Application for a works approval

Works approval number	W6620/2021/1
Applicant	Renergi Pty Ltd
ACN	160 694 388
File number	DWER2021/000557
Premises	Collie Pyrolysis Plant Gibbs Road COLLIE WA 6225
Date of report	18 March 2022
Status of report	Final

▲ *Figure 1: Simplified pyrolysis process flow*

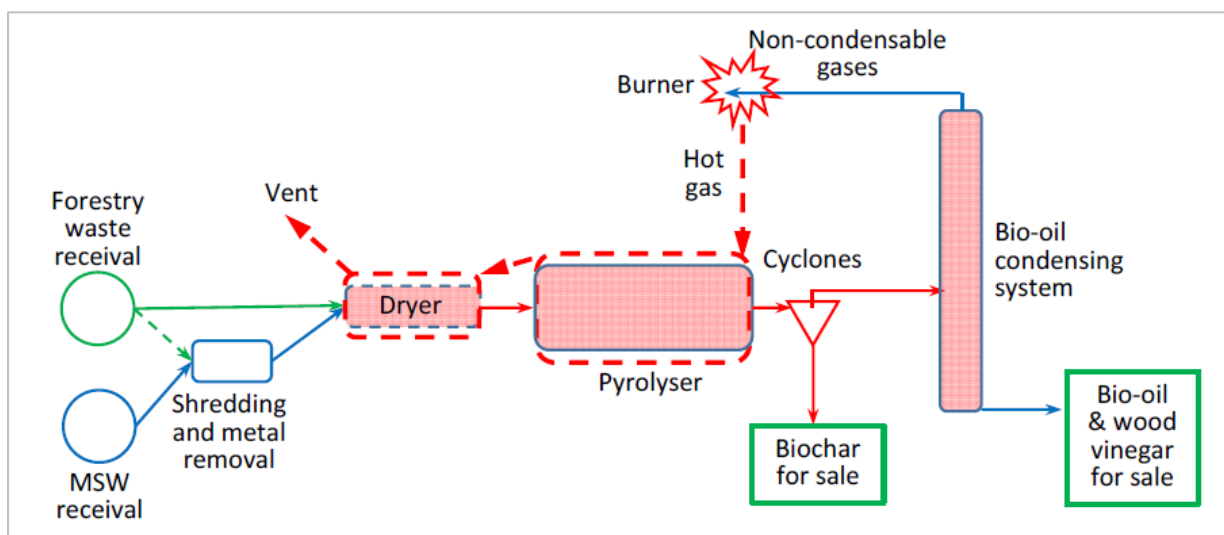
2.3 Proposal Details	Noted that during commissioning the pyrolysis plant will process MSW and forestry waste together not consecutively.	The delegated officer considered the request to remove the word 'consecutively' appropriate as processing the two feedstock types together during commissioning will not change the risk profile. The delegated officer
